Project Name : Land at Hanlye Lane, Cuckfield

Job No : 23-148

Note Title : Flood Risk Assessment and Drainage Strategy Addendum No. 1

Date : October 2024

Drawing Title
DRAINAGE STRATEGY

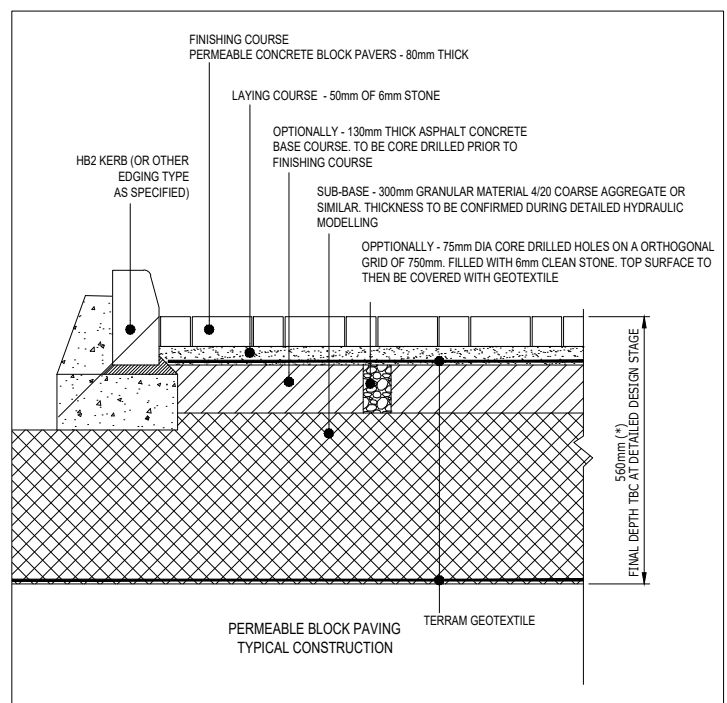
1.1.3 Since the submission of the planning application, there have been discussions with MSDC regarding four trees located across the centre of the site, through the central boundary separating the northern and southern parcels of land. Following these discussions, the site layout has been amended to remove all development from the root protection areas (RPAs) and extended buffer zones of the four trees. As such, the revised development proposal comprises 50 dwellings. The site layout is presented in **Appendix A**.

1.1.4 This technical note sets out the drainage strategy for the updated site layout, and should be read in conjunction with the submitted FRA.

2.1.1 The proposed surface water drainage strategy described below is outlined in **Drawing 23-148-001K**. It builds upon the principles of the previously submitted drainage strategy.

K	PLAY AREAS OMITTED FROM GREEN LUNG SPACE.	LG	SW	SW	14/10/24
J	UPDATED TO SUIT LATEST ARCHITECT LAYOUT	RMLLG	SW	SW	11/10/24
I	OPTION 1 OUTLET MOVED TO FALL WITHIN SITE BOUNDARY LINE	AK	SW	SW	16/09/24
H	LAYOUT AMENDED TO REFLECT THE REVISED PLANNING LAYOUT	LG	SW	SW	17/06/24
G	DRAINAGE LAYOUT FURTHER UPDATED TO CLIENT'S COMMENTS	LG	SW	SW	29/04/24
F	DRAINAGE LAYOUT FURTHER UPDATED TO CLIENT'S COMMENTS	AK	SW	SW	26/04/24
E	DRAINAGE LAYOUT UPDATED TO CLIENT'S COMMENTS	AK	SW	SW	25/04/24
D	UPDATED TO SUIT REVISED PLANNING LAYOUT	JK	SW	SW	09/02/24
C	EXISTING POND AND POND OUTFALL NOTES ADDED TO CLIENT REQUEST. POND OUTFALL ROUTE ADDED INDICATIVELY. LAYOUT UPDATED TO LATEST ARCHITECT CHANGES RECEIVED 04-10-2023	SW	SW	SW	04/10/23
B	DRAWING TITLE AMENDED. MINOR DRAINAGE CHANGES TO CLIENT COMMENTS. LAYOUT UPDATED TO ECE ARCHITECTURE DRAWING 7343 PL-04 REV E.	SW	SW	BAC	12/09/23
A	EASTERN MOST POND SIZE INCREASED.	SW	SW	BAC	05/09/23

2.1.2 Owing to the poor infiltration properties of the underlying geology, it is proposed that surface water generated by the development would be attenuated on site using a series of basins, before being discharged to the watercourse located along the western site boundary. A swale would also be incorporated within the centre of the site for surface water conveyance, owing to the topography.

2.1.3 The attenuation basins have been designed, based on a Quick Storage Estimate, to accommodate flows for all rainfall events up to and including the 1 in 100 year plus 45% climate change storm. An additional 10% of the proposed roof area has been incorporated to account for urban creep. Flows would be restricted to the QBAR greenfield runoff rate, which mimics the existing scenario, as set out in **Table 2.1**

3.1.2 Since the submission of the planning application, the development proposals have been amended owing to the removal of development within the RPAs of four trees on site, and now comprise 50 dwellings. The drainage strategy has been updated to suit the revised layout.

3.1.3 It is proposed that surface water generated by the development would be attenuated on site using a series of attenuation basins, prior to being discharged to the watercourse located along the western site boundary.
